### Proposed Changes to Operating Licenses and Technical Specifications for Dresden Nuclear Power Station, Units 2 and 3

# **Supplement to Environmental Report**

**Dresden Nuclear Power Station**

**Extended Power Uprate**

**Figure 2-1.** A schematic description of the Dresden Nuclear Power Station cooling water systems.

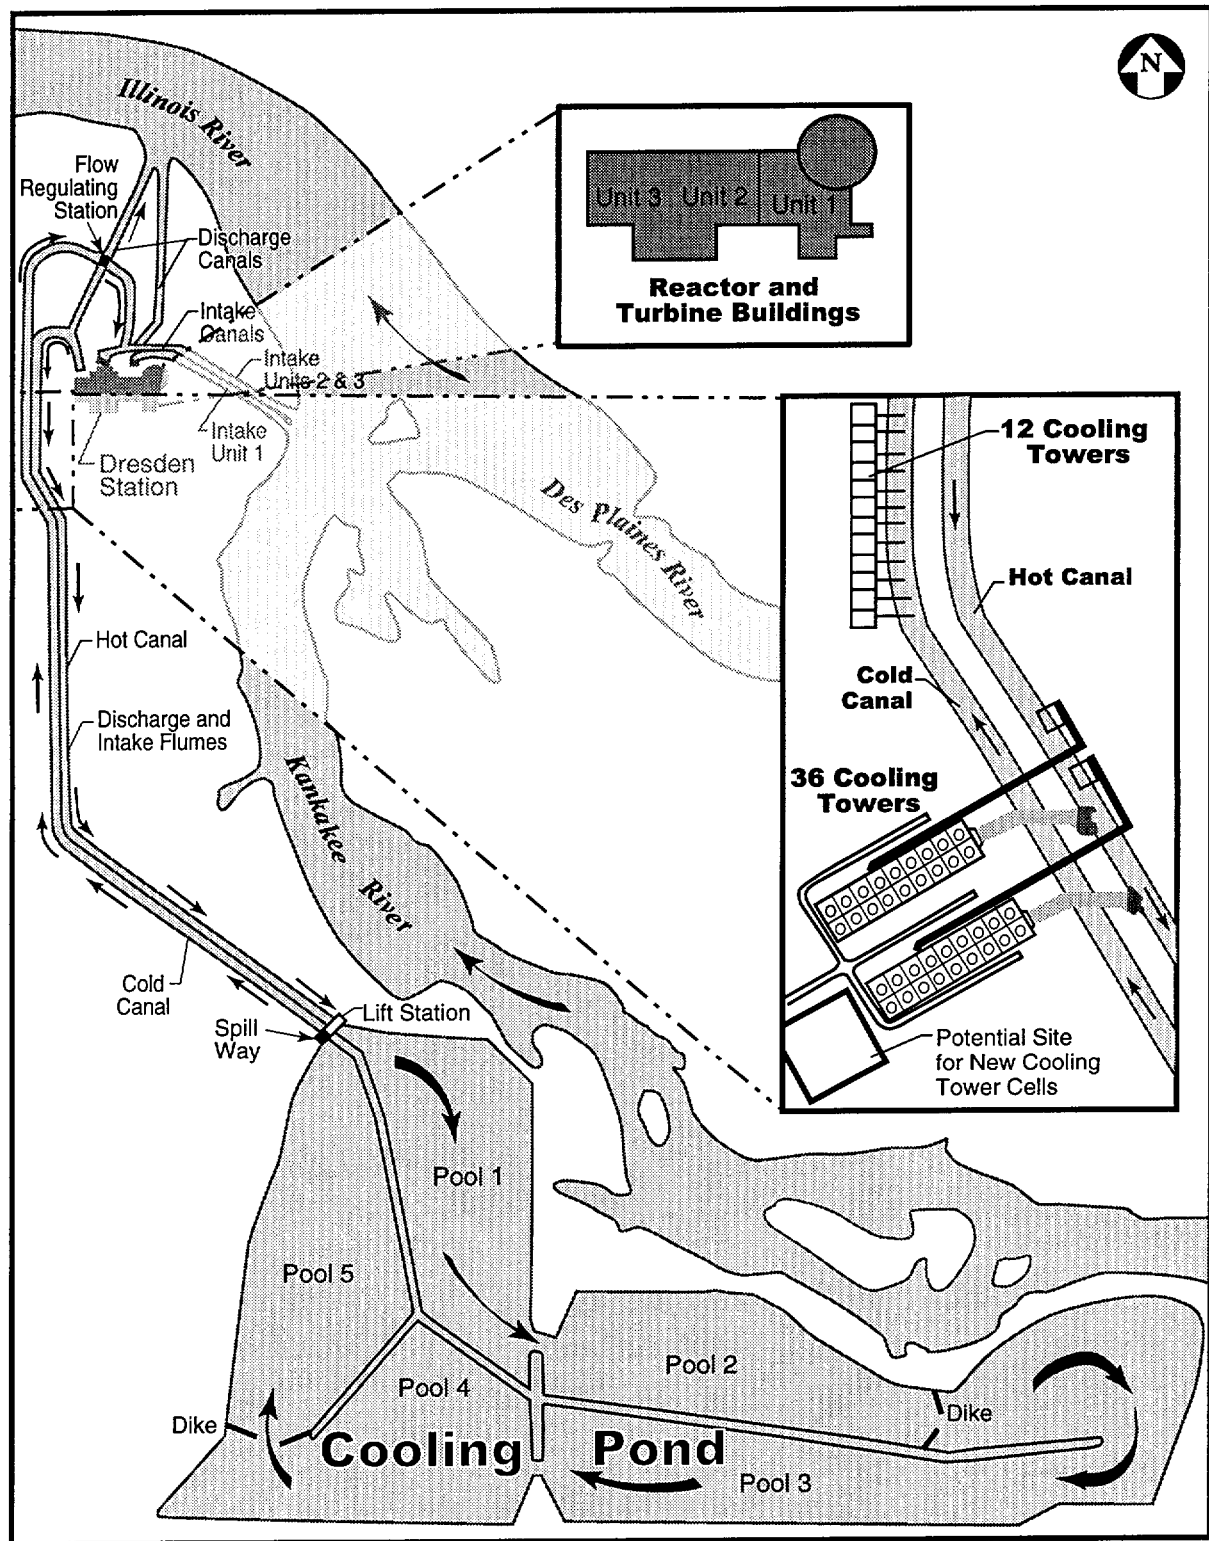
Water heated by DNPS Units 2 and 3 is cooled using a heat dissipation system consisting of a cooling pond, cooling canals, and mechanical draft cooling towers. The cooling system for Units 2 and 3 can be used for two modes of operation: indirect open cycle and closed cycle. Pursuant to the National Pollutant Discharge Elimination System (NPDES) permit, DNPS may operate in indirect open cycle mode from June 15 through September 30. Closed cycle operation is permitted at any time (Ref. 5). DNPS is also permitted to use a variable cooling water discharge plan from June 1 to June 15. Under this plan, when the cooling water temperature entering the condenser exceeds 91.5 degrees Fahrenheit (°F), DNPS may increase the flow of water from the Kankakee River added to the cooling pond return flow to keep the condenser inlet temperature from exceeding 91.5 °F. Section 3.2, "Non-Radiological Environmental Impacts," has greater detail on the hydrologic effects of indirect open cycle and closed cycle operations.

Approval of the proposed EPU would result in some minor modifications to current land use at DNPS. These changes are associated with the addition of six to eight new mechanical draft cooling tower cells to the 48 existing cells (Ref. 8 and Ref. 9). Also, due to a small increase in the number of fuel assemblies used in each cycle, the current DNPS plans for dry cask storage may be increased to add an additional storage pad with an area of less than one-tenth acre.

The new cooling tower cells will require approximately 0.5 acre. Other cooling tower impacts such as access roads and pipe bridge installation may require additional disturbance, although this impact should be less than the footprint of the cooling tower cells. The location of the new cells is in an area that has been previously disturbed (Figure 2-1). ComEd is evaluating the engineering requirements of the siting options within this general area.
